Landscape Referral Response

Application Number:	DA2019/1522
Date:	14/05/2020
Responsible Officer:	Anne-Marie Young
Land to be developed (Address):	Lot 2 DP 7391 , 43 Beach Road COLLAROY NSW 2097 Lot 1 DP 300846 , 41 Beach Road COLLAROY NSW 2097

Fig.1 Extract from Survey Plan showing existng dwelling and levels adjacent to Tree 13

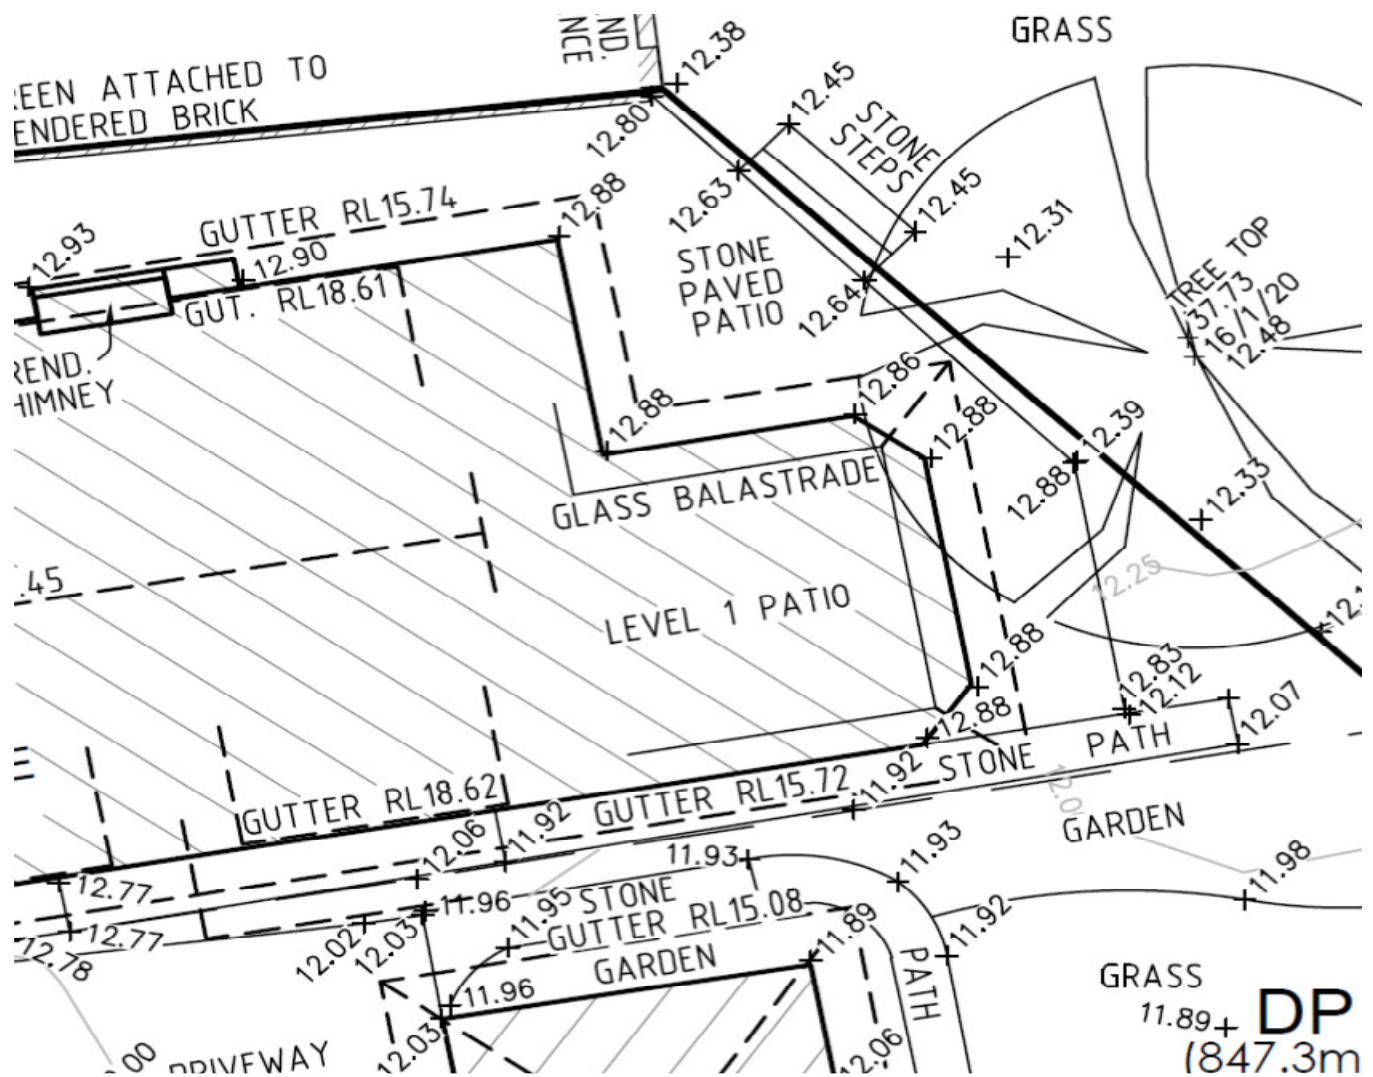
It is recognised that the existing dwelling is located very close to Tree 13, however comparison of existing levels and proposed levels indicates that the new level in the rear yard will be approximately 800mm below the existing levels.

Photo 1 below indicates the relationship between the existing dwelling and Tree 13. It is recognised that the levels shown on the Survey Plan (Fig. 1 below) are raised. Excavation below the level of the existing terraces will however still be required to achieve the levels proposed on the plans provided.

This is considered to be a significant impact on the TPZ and SRZ of Tree 13.

In order to minimise the impacts on the tree to an acceptable level, it is recommended that the ground levels immediately below the terraces and existing dwelling within the TPZ of Tree 13 be maintained and any reshaping of the landform to provide for water diversion and marrying-in to new floor levels occurs outside of the TPZ of Tree 13. This would be still be required to be undertaken under the supervision of the Project Arborist and responding on site to the below ground conditions once the terraces and existing building have been removed.

Fig.2 Extract from Ground Floor Plan showing outline of existing building, proposed building and levels adjacent to Tree 13.

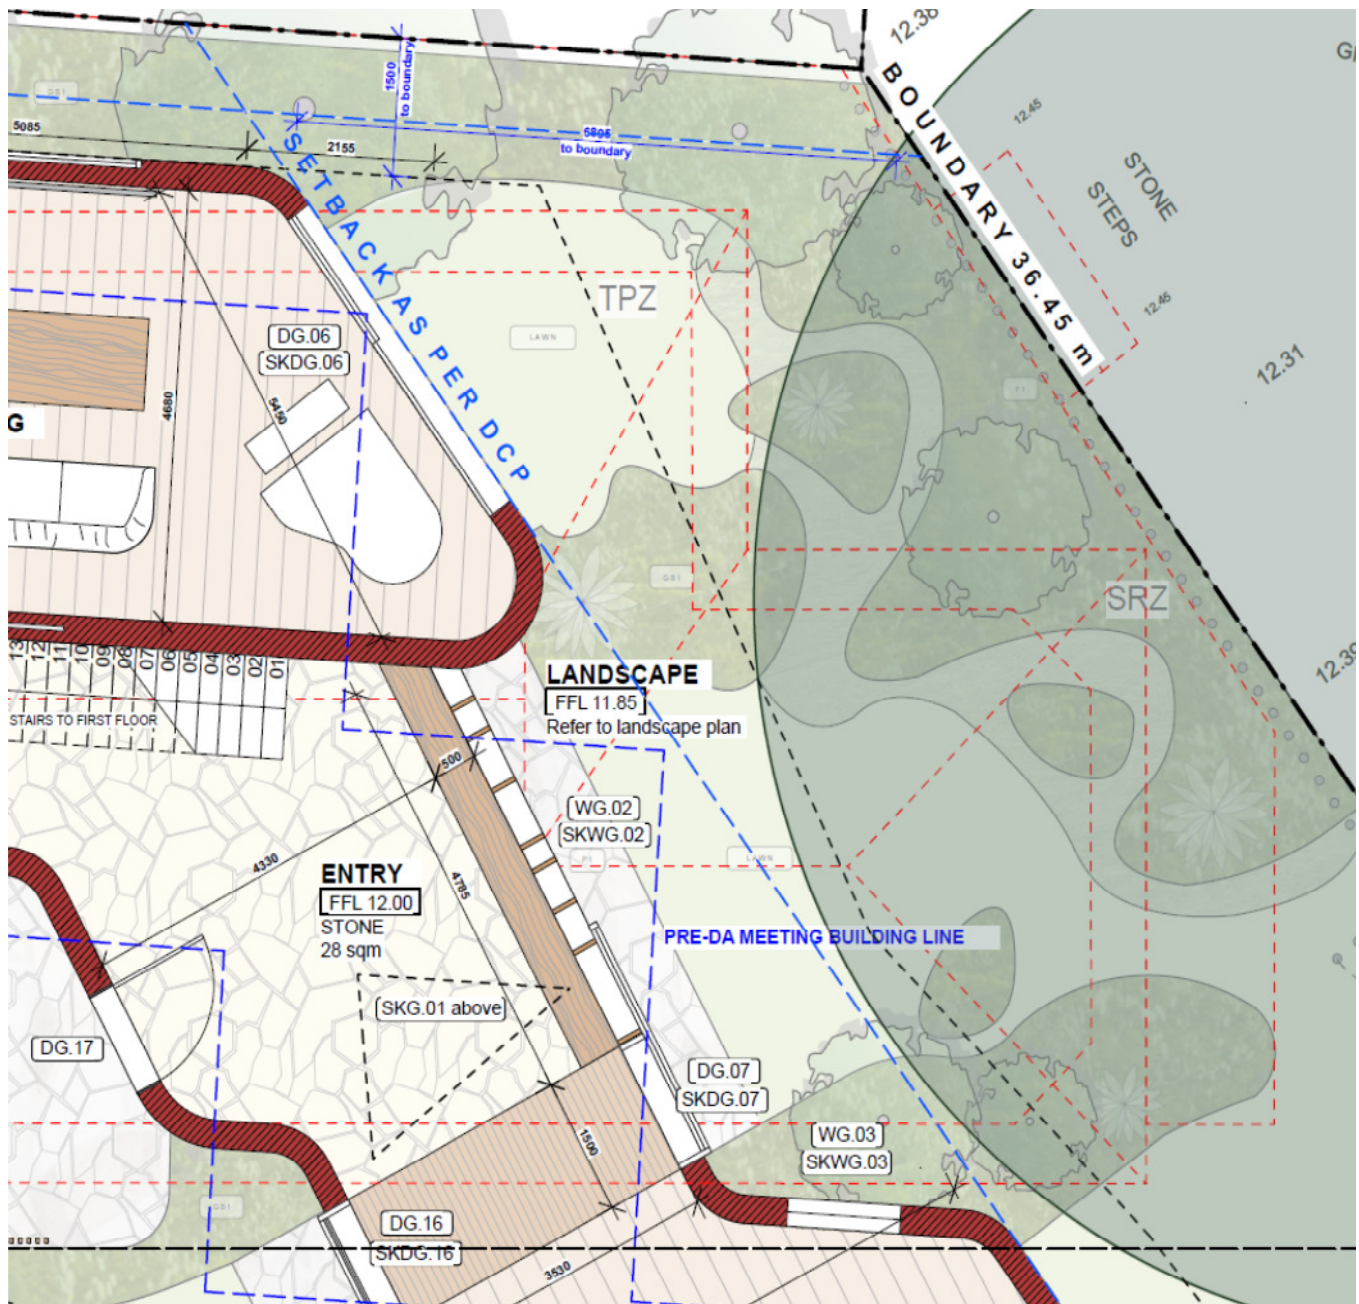
The impacts on Tree 13 are more significant with works proposed within the theoretical Structural Root Zone (SRZ) of the tree.

Architectural, Landscape and Stormwater Plans that excavation is proposed at ground level within a significant portion of the tree's TPZ and SRZ.

a) Plans are to be amended to clearly indicate that ground levels beneath the existing structures on site that occur within the Tree Protection Zone of Tree 13, as identified in the Construction Impact Assessment and Management Plan dated May 2019 prepared by Botanics Tree Wise People, are to be unaltered during demolition and construction.

b) Plans are to be amended to indicate that alteration of ground levels to accommodate stormwater flows and to marry-in to new building levels are to occur outside of the Tree Protection Zone of Tree 13. Alteration may only occur with the authorisation and under the supervision of the Project Arborist on site.
